Robinson File No: 13510

Serial: RNP-RA/97-0208

**H. B. ROBINSON STEAM ELECTRIC PLANT, UNIT NO. 2
DOCKET NO. 50-261/LICENSE NO. DPR-23
RESPONSE TO REQUEST FOR ADDITIONAL INFORMATION REGARDING
SWITCHOVER OF THE EMERGENCY CORE COOLING SYSTEM FROM
INJECTION TO RECIRCULATION PHASE**

H. B. Robinson Steam Electric Plant, Unit No. 2
Response to Request for Additional Information Regarding Switchover of the
Emergency Core Cooling System From Injection to Recirculation

Figure 2.1 Cladding Temperature at PCT Node (8.75 ft) - Initial Phase
(Data taken from Reference 2.3.4 LBLOCA initial blowdown phase)

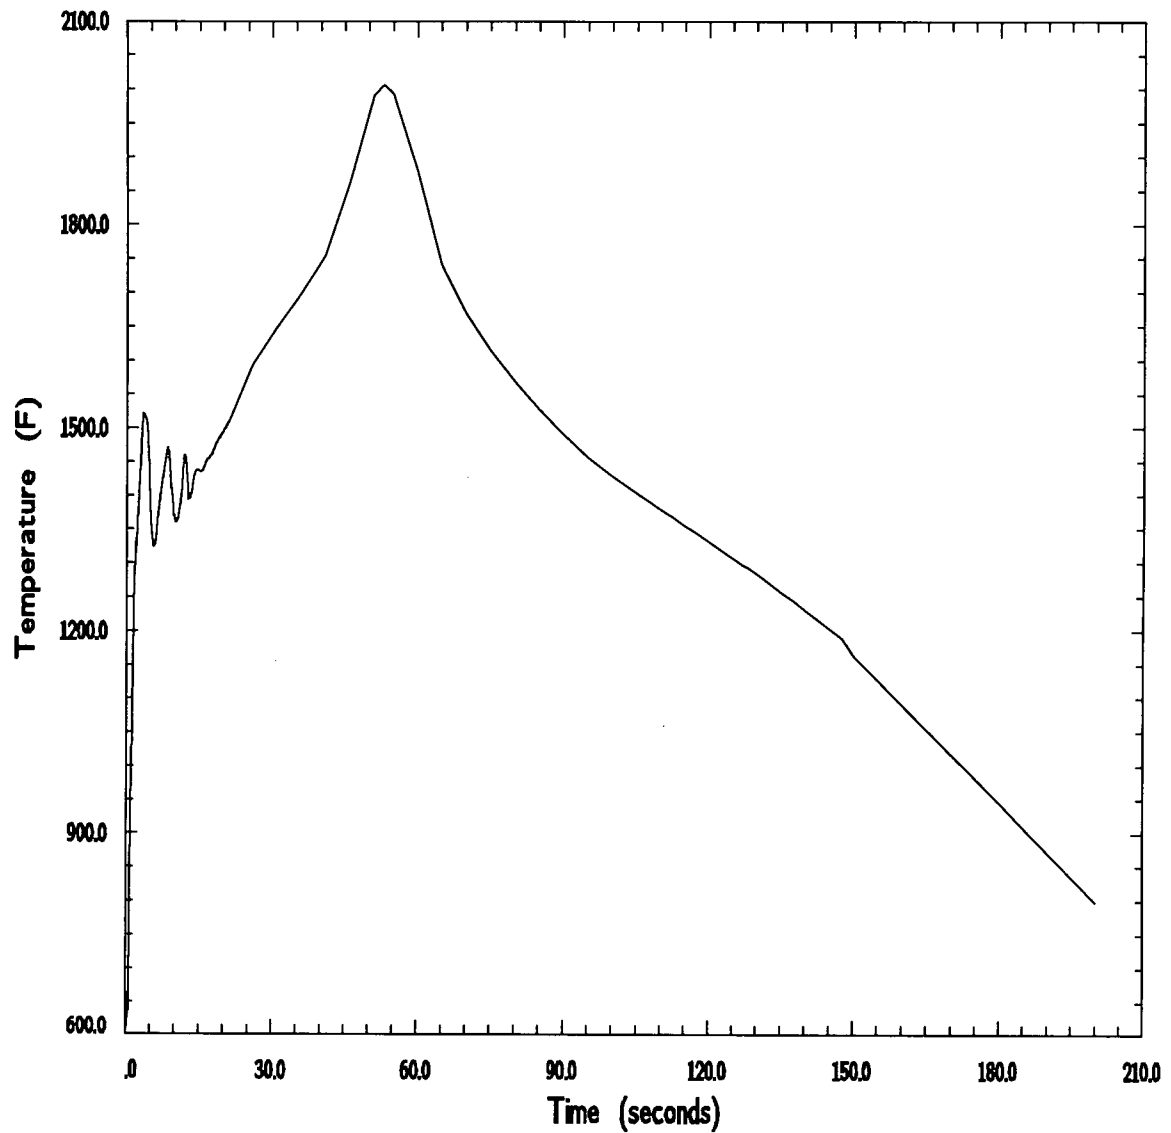
By letter dated August 26, 1997, the NRC requested that H. B. Robinson Steam Electric Plant (HBRSEP), Unit No. 2 provide information to justify the implementation of an emergency procedure that allows operators 30.5 minutes to complete the transfer from the injection phase of the Emergency Core Cooling System (ECCS) to the recirculation phase with respect to the effects that thermal cycling would have on the fuel cladding, and, particularly, criterion (4) of 10 CFR 50.46. The NRC further requested that a discussion, results, and references to cladding performance tests or experiments to support this action be provided.

Figures 2.1 and 2.2 show the temperature trends at the PCT node for the initial phase and the second heat-up, respectively. The initial phase trace was taken from the HBRSEP, Cycle 17 LBLOCA Analysis performed in 1995 (Reference 2.3.4), and the second heat-up trace was taken from the switchover analysis (Reference 2.3.1). In the case of the Reference 2.3.4 analysis, the PCT was approximately 2,006°F. The Reference 2.3.5 LBLOCA initial phase PCT was approximately 2178°F, indicating that the switchover analysis used a conservatively high "initial phase oxidation state" in its analysis, relative to what would be used today.

The PCT for the initial portion of the LBLOCA event calculated in 1996 (Reference 2.3.3), was 2064°F and it occurred at approximately 1 minute (61.1 seconds) following the break. The maximum oxidation for any axial node on the hot rod was 3.86% and the hot rod average was 0.674%. The PCT node and the rupture node coincided for the MOC case at 8.75 feet. These analysis results continue to show that the switchover analysis (Reference 2.3.1) used a conservatively high "oxidation state" of the fuel rods in its initialization for the switchover.
